LR-N22-0044

Salem Nuclear Generating Station, Units 1 and 2
Renewed Facility Operating License Nos. DPR-70 and DPR-75
NRC Docket Nos. 50-272 and 50-311

Hope Creek Generating Station
Renewed Facility Operating License No. NPF-57
NRC Docket No. 50-354

Subject: Emergency Plan Document Revisions Implemented November, 2021.

Hope Creek-Release In Progress Determination Guidance

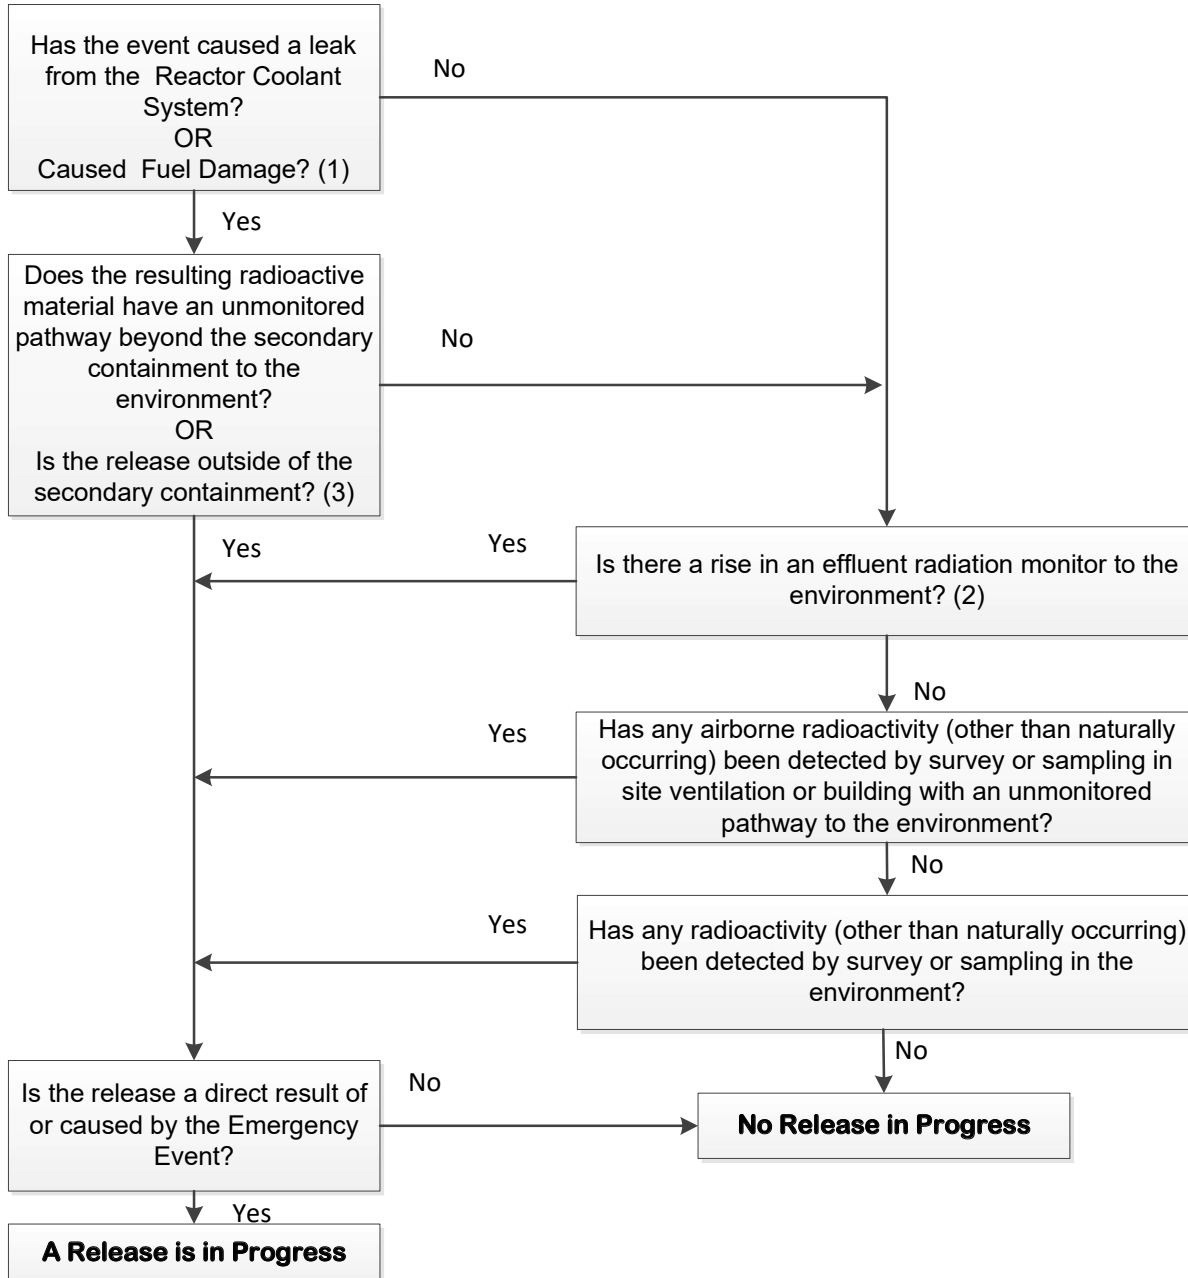
- Revised ICMF approval from "EC Initials" to "EC Print/Sign". All required PSEG approvals for documentation require Print/Sign.
- Added Radioactive Release Determination Flow Chart. The chart is being added to provide clarification to the decision making process for radiation release determination.

Salem-Release In Progress Determination Guidance

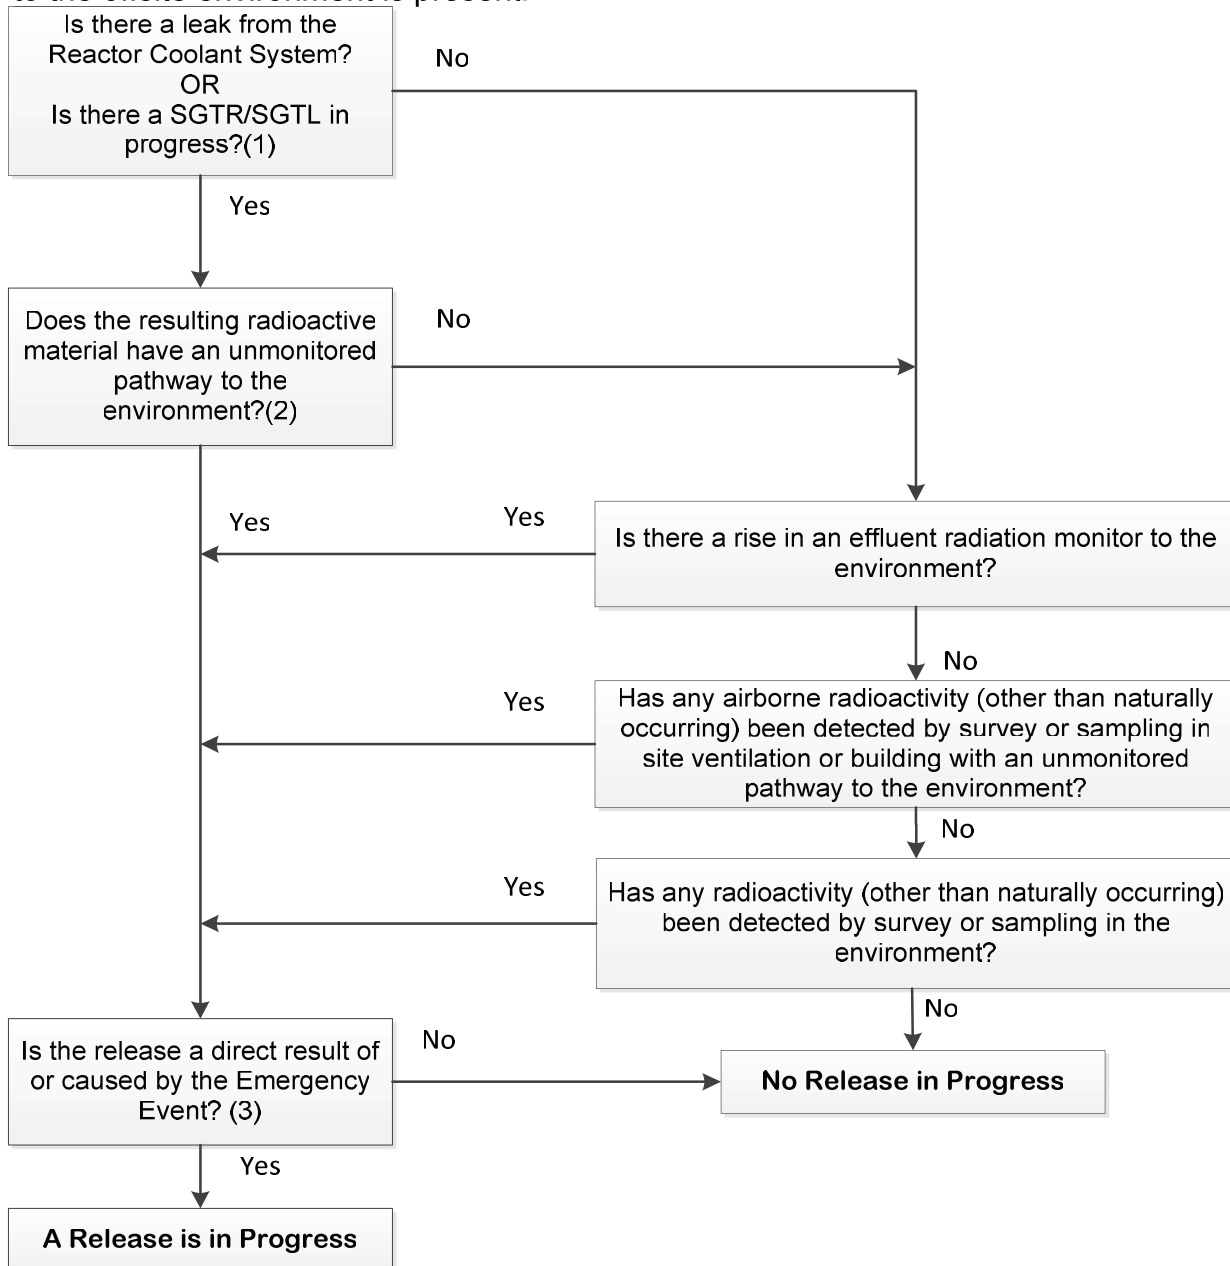
- For EP-SA-325-F1, Moved bullet item "UPDATE the Crew/Facility with the Emergency classification level and potential escalation criteria" up to Section A Step 3. This step is being moved to ensure crew/facility is aware of Emergency Classification/Escalation criteria in a timely manner.
- For EP-SA-325-F2, F3, F4 & F24, Moved bullet item "UPDATE the Crew/Facility with the Emergency classification level and potential escalation criteria" up to Section A Step 4. This step is being moved to ensure crew/facility is aware of Emergency Classification/Escalation criteria in a timely manner.
- Revised ICMF approval from "EC Initials" to "EC Print/Sign". All required PSEG approvals for documentation require Print/Sign.
- Added Rad Release Determination Flow Chart. The chart is being added to provide clarification to the decision making process for radiation release determination.
